Agenda – Standing Policy Committee on Property and Development, Heritage and Downtown Development – May 27, 2019

Item No. 13 Subdivision and Rezoning – 206, 216, 218, 228, 230, 236, 244 and 248 Good Street
(Fort Rouge – East Fort Garry Ward)
File DASZ 28/2018 [c/r DAV 184543/2018D]

Department:	Planning, Property and Development
Division:	Urban Planning
Prepared by:	Andrew Ross, RPP, MCIP
Date:	April 26, 2019
File No:	DASZ 28/2018

DATE:	April 26, 2019
FILE:	**DASZ 28/2018**
RELATED FILES:	DAV 18-184543D
COMMUNITY:	City Centre Community
NEIGHBOURHOOD #:	**103** - West Broadway
SUBJECT:	For a subdivision and rezoning for DASZ 29/2018 – 206-248 Good St, for the construction of a 6-storey, 145 unit residential building.
LOCATION:	206 Good ST
LEGAL DESCRIPTION:	LOT 28/29 PLAN 33124 84/85 ST JA

Figure 3: Main floor height visualization. See Appendix 1 for larger view.

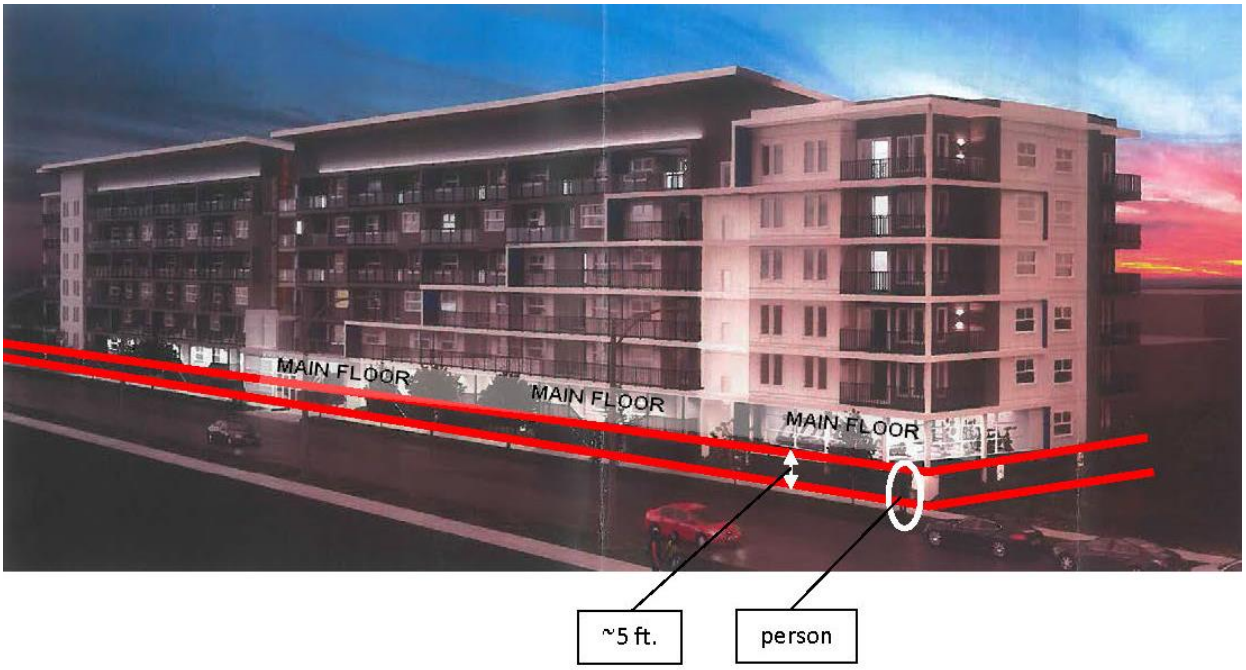
Over the past year, the Urban Planning Division has engaged regularly with the applicant in attempt to come to a positive design solution regarding the building's street condition (the way in which the building presents itself to the street). The following is the Division's position on this issue.

- For the proposed development, the plans show that the building facade on Good St. contains a series of 10-step staircases (5+ ft.) leading up to a raised main floor along the 390 ft. length. Below that, at street level, there is a brick wall with a height of 5+ ft. concealing a parking garage.

- The urban design standard limiting height of the main floor above parking facilities is well recognized and reflected in some cities' residential design guidelines. As an example, the City of Abbotsford's Multifamily Residential Development Permit Guidelines Part V - 2 - 6 MF15 Underground Parking state, *"Avoid designing underground parking that exceeds grade level height. Where underground parking structures must be partially above grade, ensure they do not exceed 1.0 metres from the ground. Use attractive, high quality materials on the exposed structure and/or screen with landscaping."*

- The plans show that the main floor of the building is raised at least 5 ft. above ground level. This removes the 'life' of the building away from street level. It leaves a brick wall and a series of 10-step staircases for the first 5+ ft. above street level. The pedestrian experience is negatively impacted because a brick wall provides no interplay between interior and exterior of the building at the sidewalk level, which can have a 'deadening' effect on the street condition.

C. That the finished main floor of the building shall not project more than ~~***3.3***~~ ***5*** ft. above grade.

Given the above, the Urban Planning Division is not satisfied that the City has been provided information suggesting the parking facility cannot be built fully below grade, or at most 3.3 ft. above grade to its highest point, in order to provide for a supportable building street condition as requested by the City.
